Environmental Planning Commission

Agenda Number: 3
Project #: 2021-005301
Case #: SI-2021-00452
Hearing Date: July 15, 2021

Supplemental Staff Report

**RE: DUTCH BROTHERS MAJOR AMENDMENT 7 BAR- EPC
RESPONSE TO COMMENTS PR-2021-005301/SI-2021-00452
3615 HWY 528, ALBUQUERQUE NM 87114
ZONE ATLAS PAGE A-14-Z**

\\TINKAS\Z_Drive\2014\2014069 Julian Garza Properties\dwg\DRB\NM-528 and Ellison\2014069-SDP.dwg Jul 02, 2021 -- 9:19am

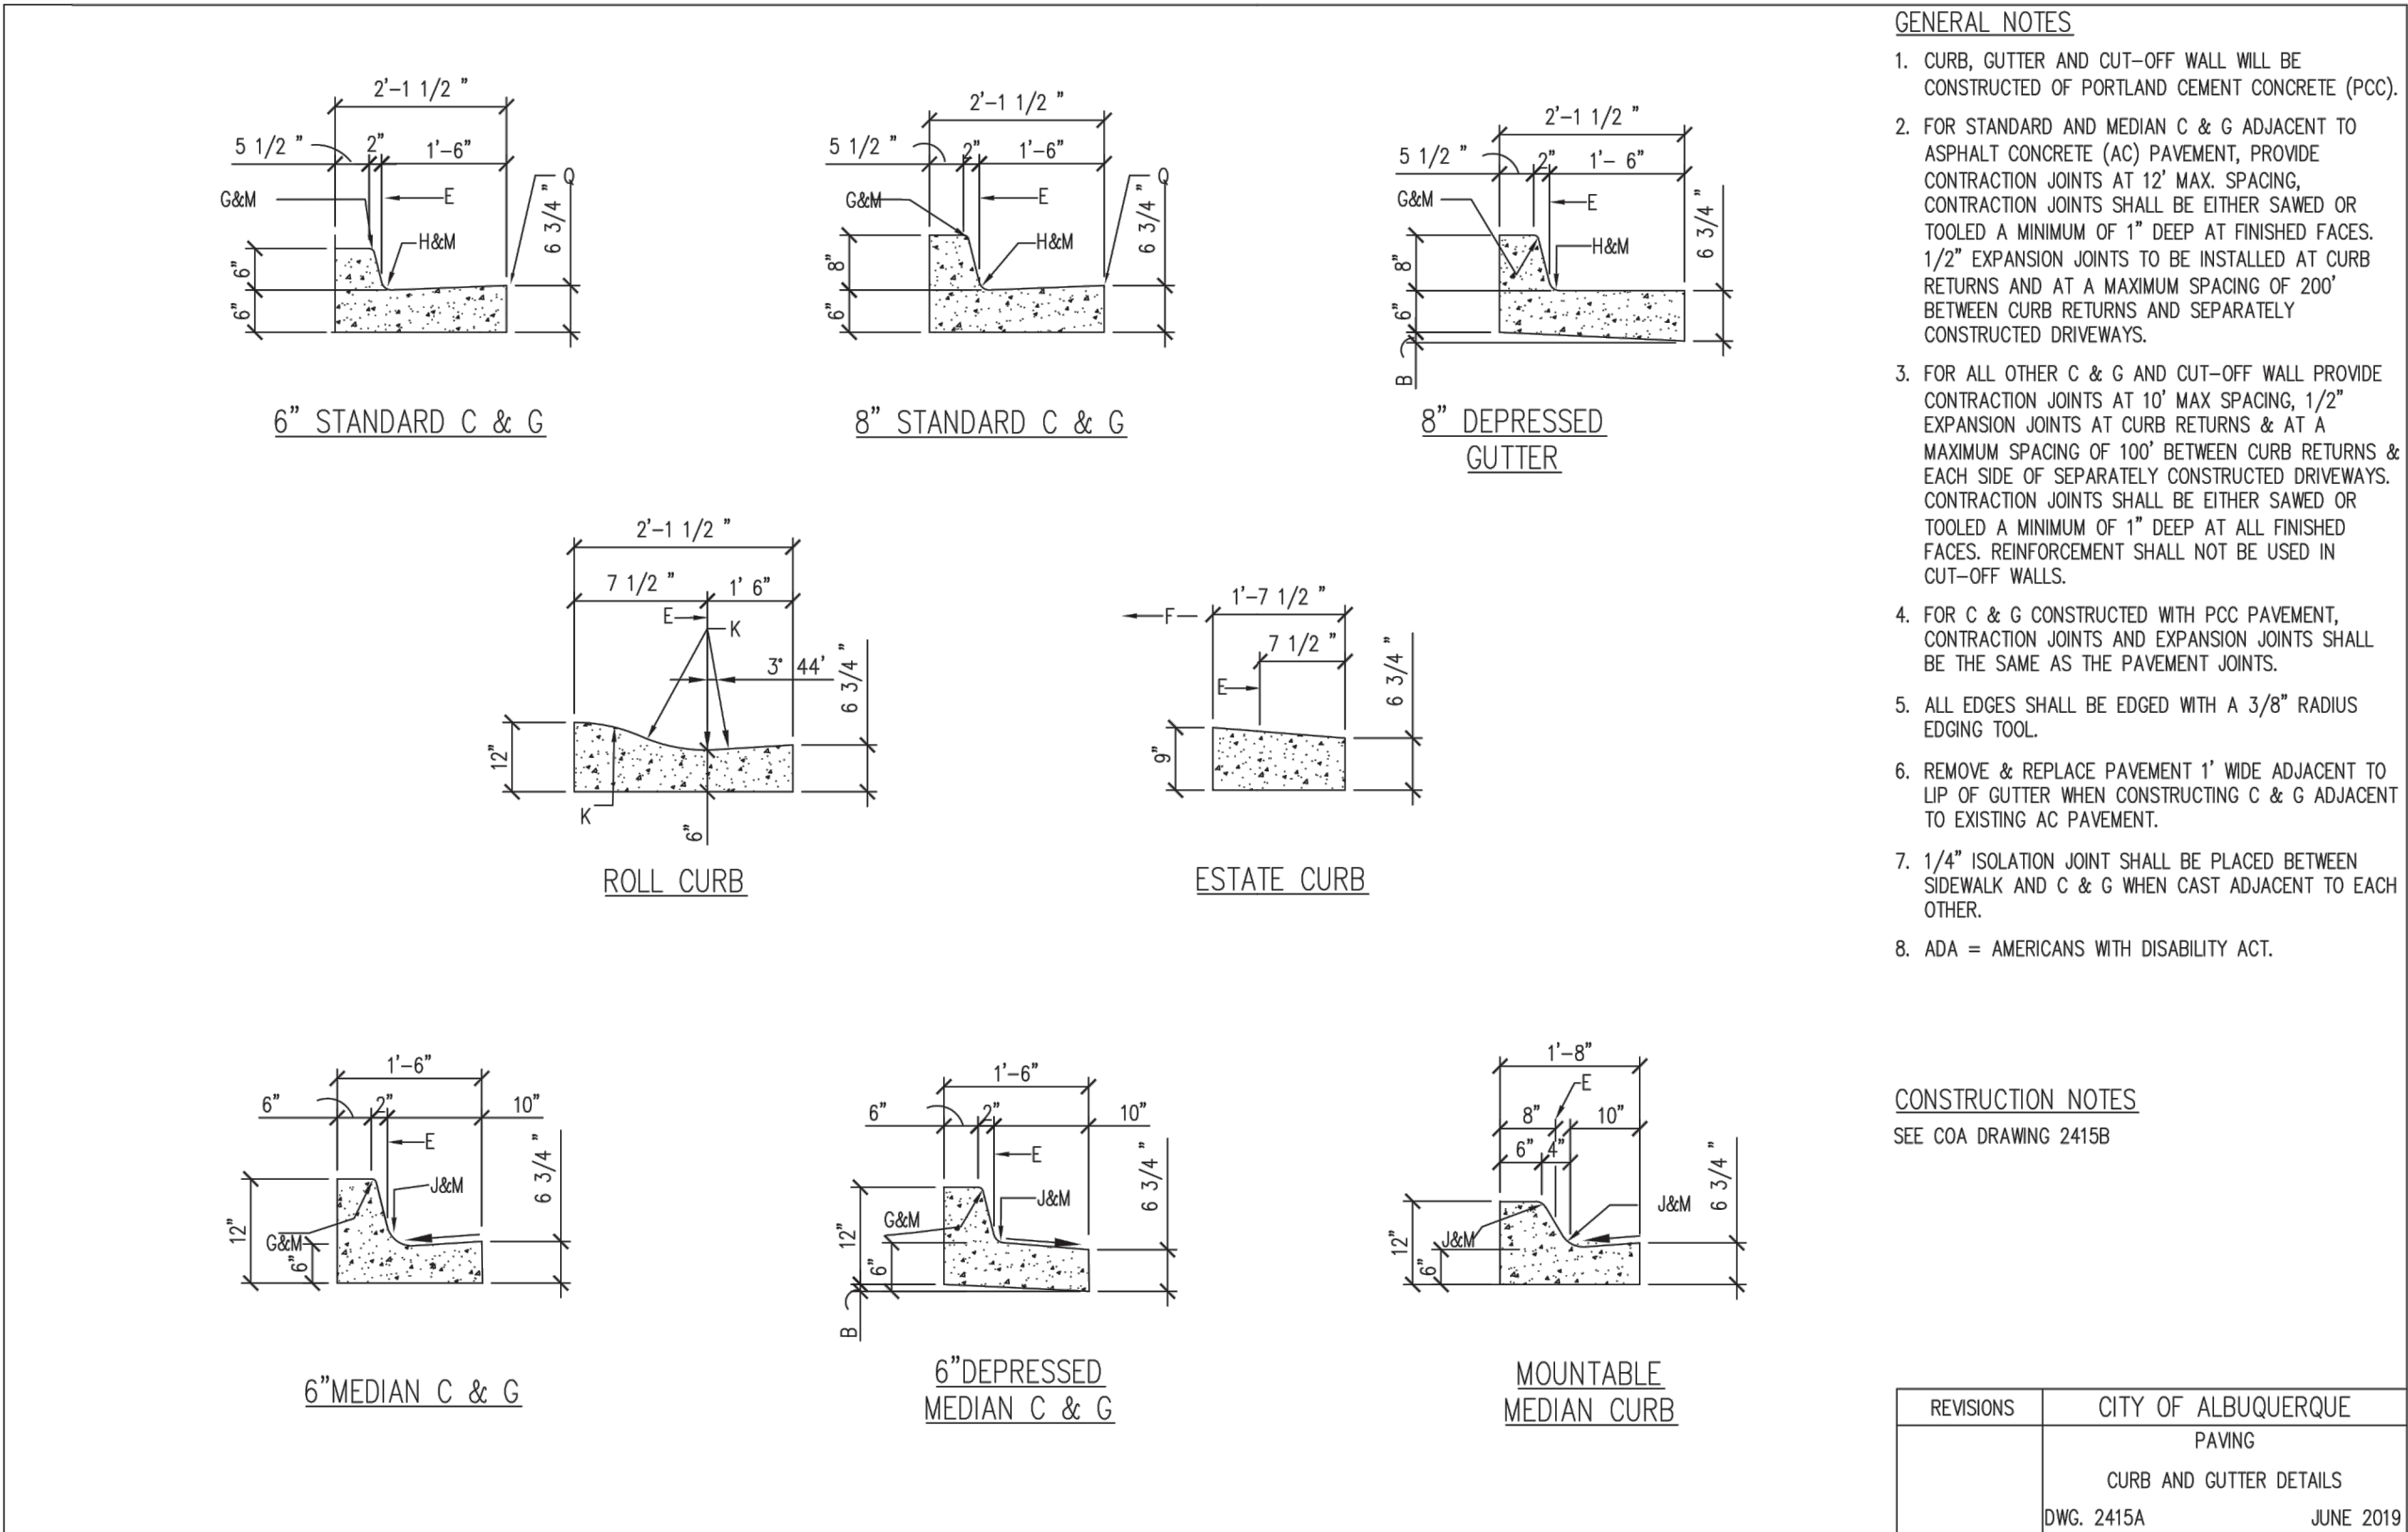
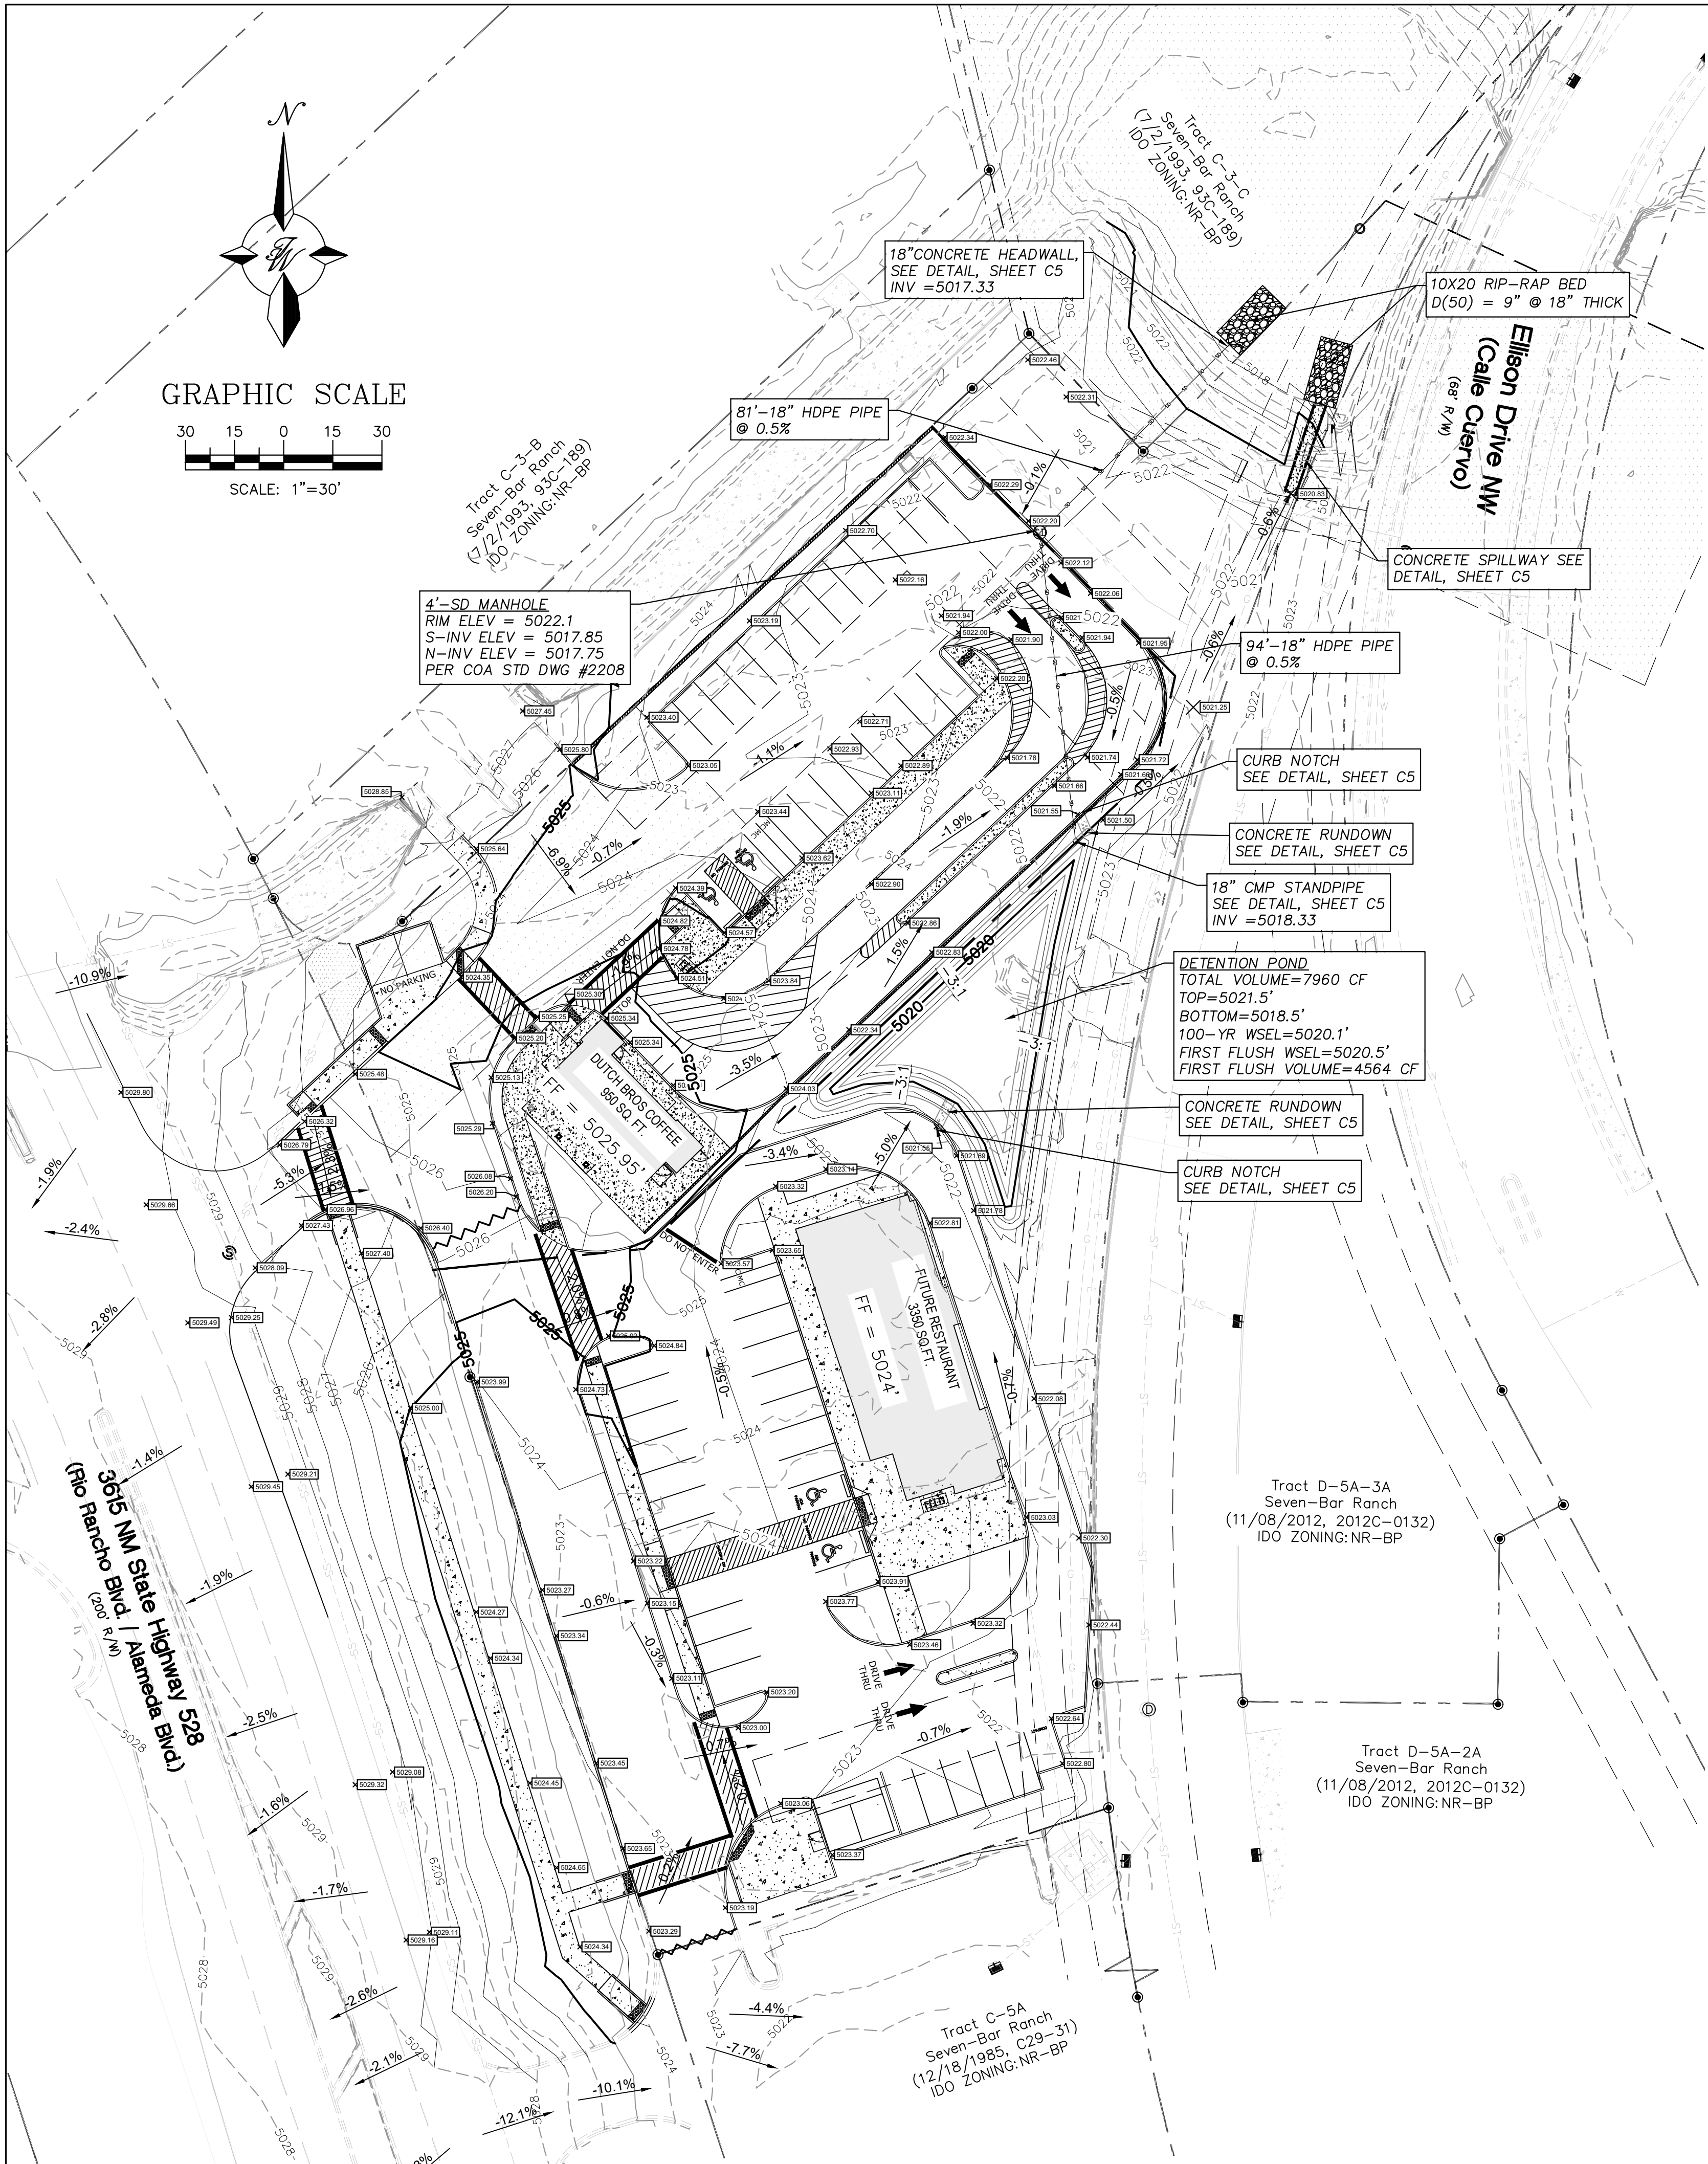
B. The landscaping calculations shall be revised to use the gross lot area specified on the main site plan (Sheet C-1), which is 86,684 sf.

A. Additional landscaping, including trees, shall be added to the area near the proposed detention pond to meet the requirement (see A, above) and to help screen the pond and the drive-thru lanes.

Response: Total landscape area provided is 18,571 sf. 15% of net lot area is 12,358 sf. Calculations are provided on the landscaping plan sheet LS-01.

Response: Revisions to calculations made on landscaping plan sheet LS-01.

Response: Revisions made to landscaping plan sheet LS-01.

Response: Revisions made to landscaping plan sheet LS-01.

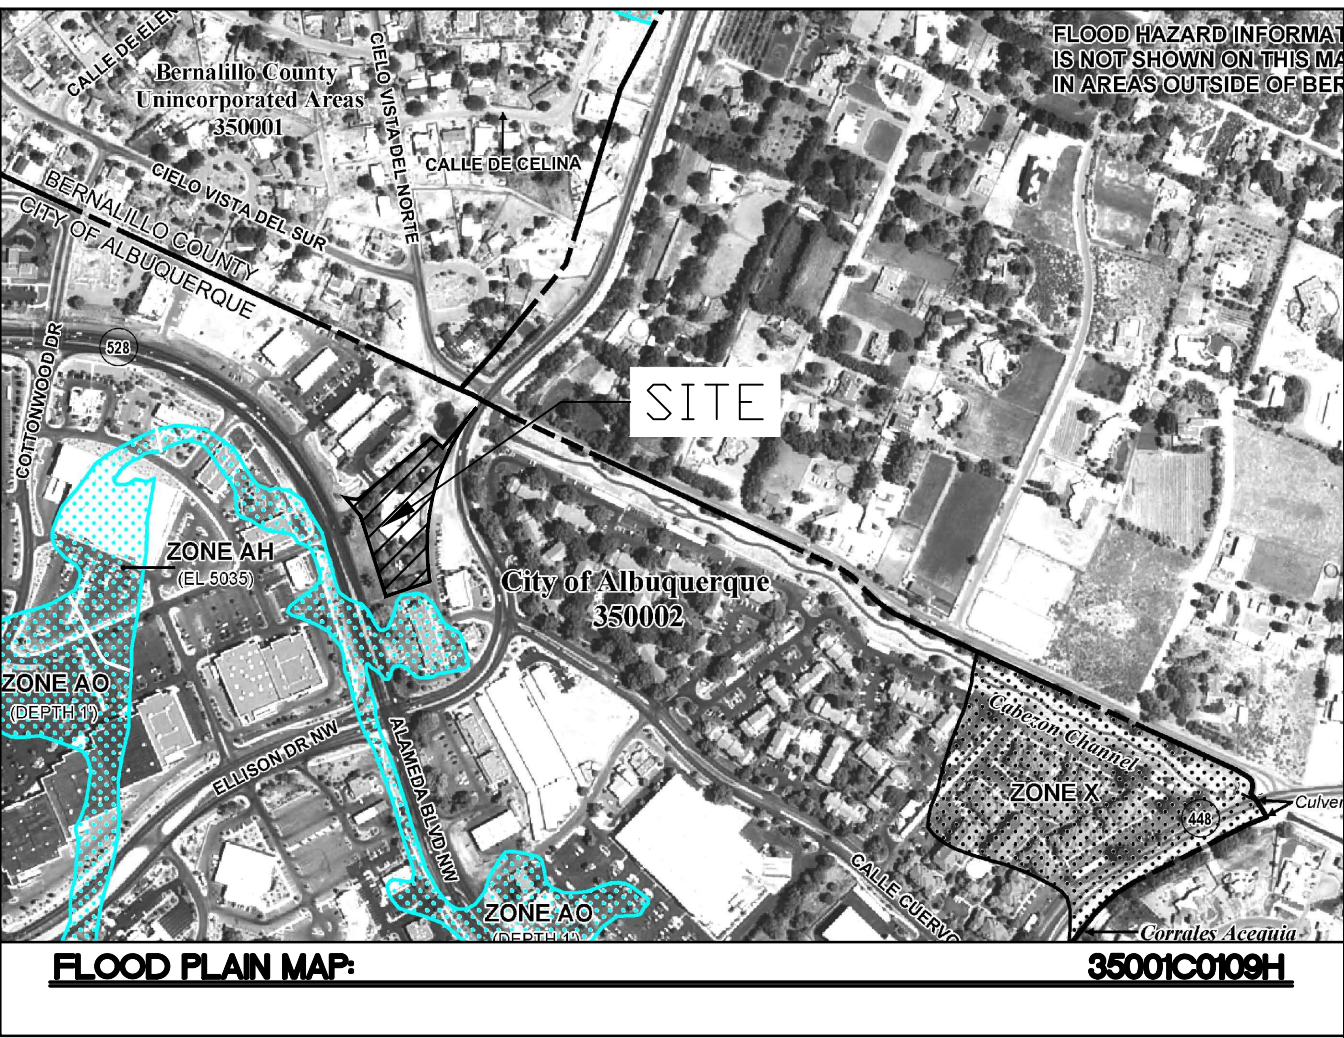
15. Grading and Drainage Plan: Curb notches shall be shown in the same locations as on the landscaping plan.

Response: Curb notches are provided and are noted on the site plan sheet C1, landscape plan sheet LS-01 and grading and drainage plan sheet C4.
